Contract #: 04-0120F4Cty: SF/ALA Rte: 80 PM: 13.2/13.9File #: 69.25B**QUALITY ASSURANCE -- NON-CONFORMANCE REPORT****Location:** Changxing Island, Shanghai, PRC**Report No:** NCR-000351**Prime Contractor:** American Bridge/Fluor Enterprises, a JV**Date:** 06-Jul-2009**Submitting Contractor:** Zhenhua Port Machinery Company, Ltd (ZPMC), Changxing Island**NCR #:** ZPMC-0325**Type of problem:****Welding****Concrete****Other****Welding****Curing****Procedural****Bridge No:** 34-0006**Joint fit-up****Coating****Other****Component:** OBG Segment 4BE**Procedural****Procedural****Description:****Reference Description:** Missed UT 4BE**Description of Non-Conformance:**

Job Name: SAS Superstructure

Subject: NCR No. ZPMC-0325

Reference Description: Missed UT 4BE

焊缝返修位置示意图:

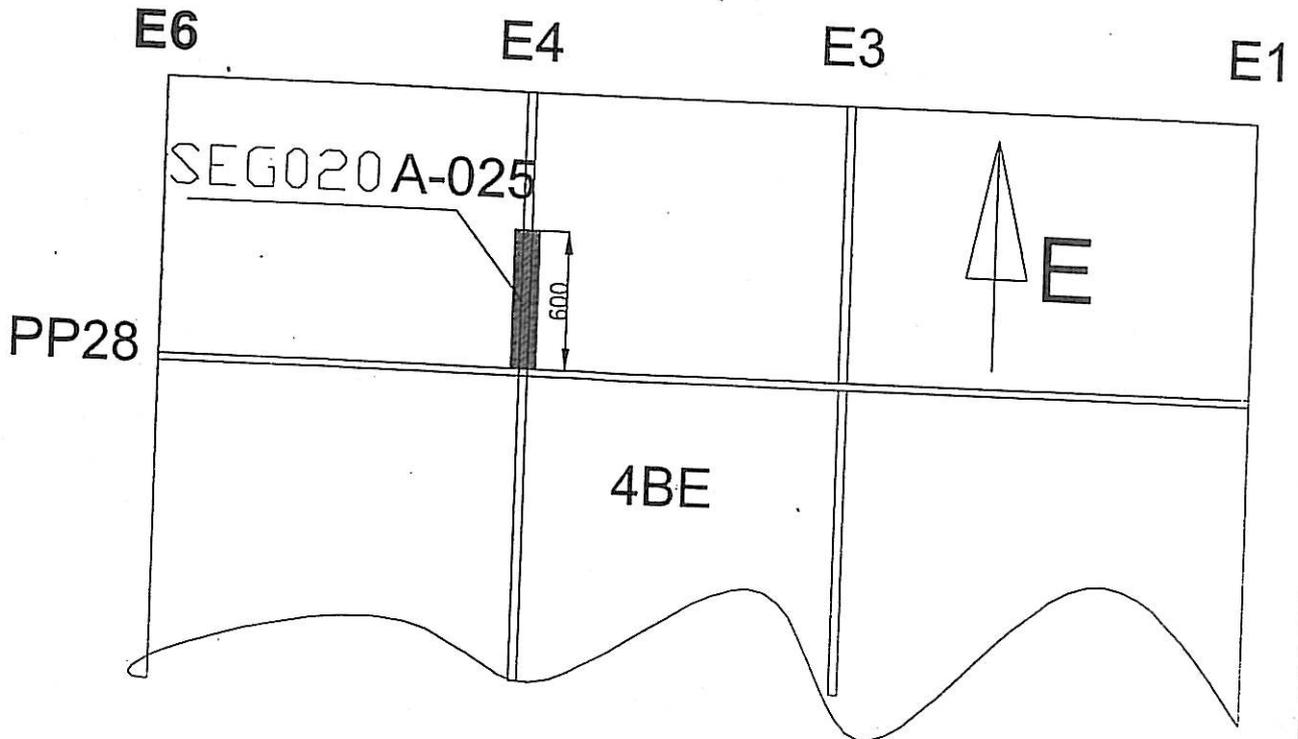
经检查发现4BE北侧底板与斜底板拐角处对接缝平整度超差达4~14mm, 总长约600mm. 其焊缝编号为SEG020A-025.

The flatness was 4-14mm at 4BE bottom plate and side plate, 600mm in length, weld No: SEG020A-025.

Weld distortion and fabricate error.

1. 采用碳刨或切割方法将平整度超差位置纵桁与底板焊缝割开L, 其次割开底板与斜底板平整底超差区域主焊缝L' (注: L、L'切割长度可根据现场实际平整度超差情况进行确定), 碳刨前应根据相应的WPS进行预热;
 2. 根据相应返修WPS准备正确的焊接接头型式, 并预制底板 (斜底板)、纵桁坡口;
 3. 借用外力 (如工艺撑、卡码等) 固定住底板与斜底板以保证平面度满足公差要求;

4. 对焊接修补区域进行VT检测确认无缺陷存在;
 5. 根据批准的返修WPS焊接底板与斜底板焊缝, 并随时检测底板与斜底板平整度, 其次焊接纵桁与箱梁底板焊缝;
 6. 将返修处焊缝打磨与周边焊缝或母材平齐;
 7. 根据图纸要求进行检测。
1. Remove L weld between longitudinal diaphragm and bottom plate by use of gouging or cutting, remove L' weld between bottom plate and side plate, (Remark: the length(L、L') was according to flatness condition on site), preheat according to approved WPS before gouging;

2. Prepare a right joint and make the groove of bottom plate(side plate) and longitudinal diaphragm;
 3. Fix bottom plate and side plate by use of force(such as technology strut, fixture) to ensure flatness;

4. Perform VT to ensure the repair area free of defects before repair;
 5. Weld bottom plate and side plate weld according to approved WPS, inspect bottom plate and side plate weld flatness, then weld between longitudinal diaphragm and box side plate;

6. Grind repair area flush with adjacent weld or base metal;
 7. Perform inspection according to drawing requirement.
